MODEL: 335XPT

SUBJECT: Sporadic Oiling

Part Number
503 82 95-01

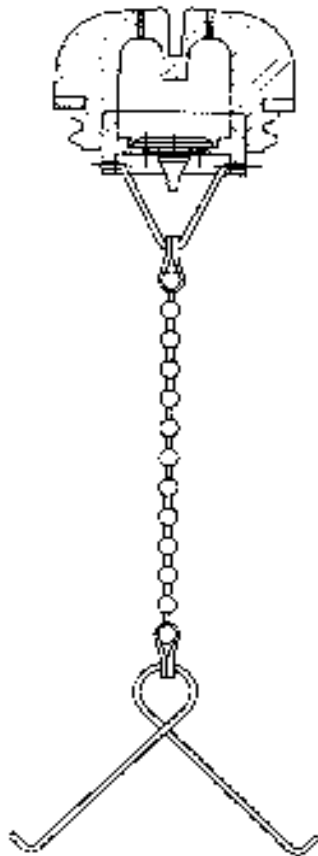
It has been reported that some saws in cooler climates tend to oil sporadic. If you should experience this, install oil cap, Part Number **503 82 95-01**.
